Access Compliance Report

Public Rights-of-Way

(Curb Ramps)

Intersection ID: 46813	Main Street: ARBOR_VISTA_DR	Cross Street: OLDE_IVY_WY	Location: SW
ADA ID: 4F40EC74A68C	Ramp Type: Perp	Initial Pass/Fail: Fail	Overall Compliance: No
Severity Score: 33.75			
Codes/Mitigation Info/Possible Solution		Field Measurements/Component Compliance

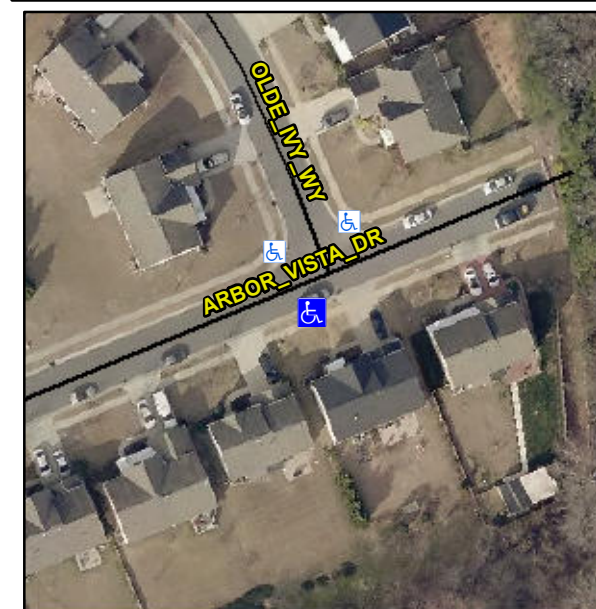
R304.5.1, R304.2.2

Compliance	Description	Data	Compliance	Description	Data
N/A	Ramp Length (in)	47.5	No	Ramp Slope (%)	12.0
No	Ramp Width (in)	45.5	Yes	Ramp XSlope (%)	0.8
N/A	Flare Type LT	N/A	N/A	Flare Type RT	N/A
N/A	Flare Slope LT (%)	N/A	N/A	Flare Slope RT (%)	N/A
N/A	Flare Traversable LT?	N/A	N/A	Flare Traversable RT?	N/A
N/A	Landing Length (in)	N/A	N/A	DWS Provided?	N/A
N/A	Landing Width (in)	N/A	N/A	DWS Contrast?	N/A
N/A	Landing Slope (%)	N/A	N/A	DWS Length (in)	N/A
N/A	Landing X Slope (%)	N/A	N/A	DWS Full Width?	N/A
N/A	Landing Curb? (Y/N)	N/A	N/A	DWS Offset (in)	N/A
N/A	Shared Landing?	N/A			
N/A	Gutter Ponding?	N/A	N/A	Gutter Slope (%)	N/A
N/A	Gutter Lip Ht (in)	N/A	N/A	Gutter X Slope (%)	N/A
N/A	Painted X Walk1?	No	N/A	Painted X Walk2?	N/A
	X Walk 1 Direction	To N		X Walk 2 Direction	N/A
N/A	X Walk 1 Width (in)	N/A	N/A	X Walk 2 Width (in)	N/A
	X Walk 1 Slope (%)	2.0		X Walk 2 Slope (%)	N/A
	X Walk 1 X Slope (%)	1.0		X Walk 2 X Slope (%)	N/A

Remove & Replace Entire Ramp.
